**APPLICATION FOR SECTION 96A - NON-MATERIAL AMENDMENT OF PLANNING
PERMISSION REF: 2021/62/93567/E (DEMOLITION OF EXISTING COMMERCIAL BUILDINGS
AND ERECTION OF 180 DWELLINGS WITH ASSOCIATED WORKS) FOR THE
DEVELOPMENT OF LAND OFF WESTGATE, CLECKHEATON, BD19 5DR.**

We hereby submit a Section 96A - Non-Material Amendment application in respect of planning permission reference 2021/62/93567/E for the development of Land at Westgate, Cleckheaton, BD19 5DR.

The approved plan: Site Layout (Dwg: BY00099-STH-B01-XX-DR-A SL001 Rev: T) is to be replaced by the following proposed plan: Site Layout (Dwg: BY00099-STH-B01-XX-DR-A SL001 Rev: W).

Figure 3 - Proposed Site Layout (Dwg: BY00099-STH-B01-XX-DR-A SL001 Rev: W)

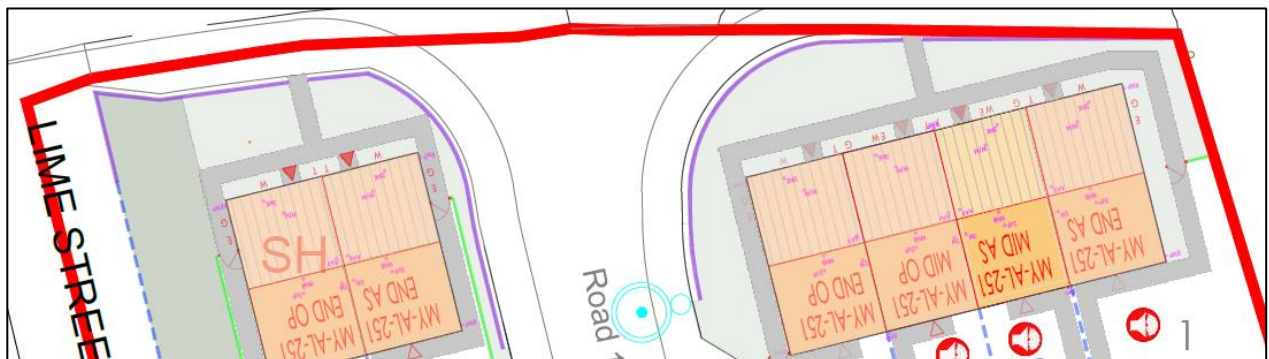
6. Replacement of 900mm Screen Wall with 600mm Screen Wall Along Site Access.

Following comments received from Kirklees Council Highways Team as part of the Section 278 process, the height of the screen wall located adjacent to the site access is to be reduced from 900mm to 600mm to facilitate the required pedestrian visibility splays.

The location of the screen wall is identified in purple on the image below.

Figure 5 - Proposed Site Layout (Dwg: BY00099-STH-B01-XX-DR-A SL001 Rev: W).

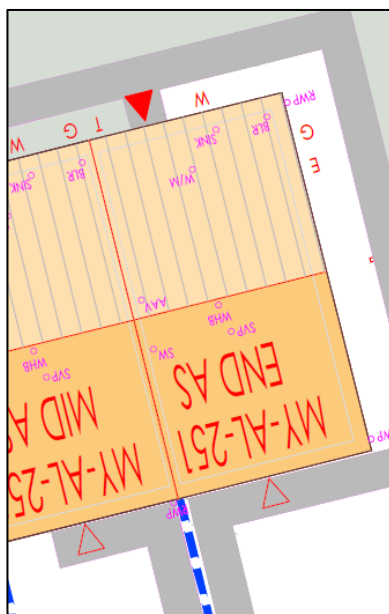
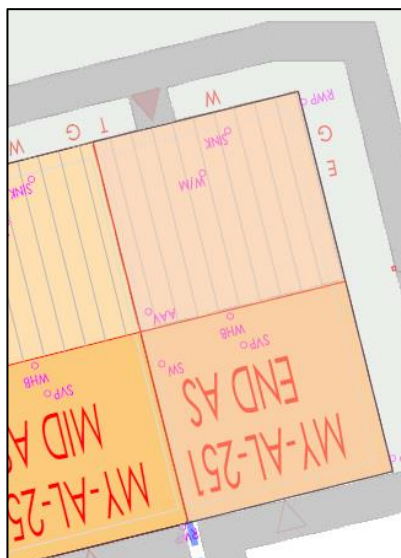
7. Reconfiguration of Plot 1 Frontage Pathway.

The frontage pathway serving Plot 1 is to be repositioned (as identified below) in order to accommodate the retaining wall which is to be installed adjacent Plot 1.
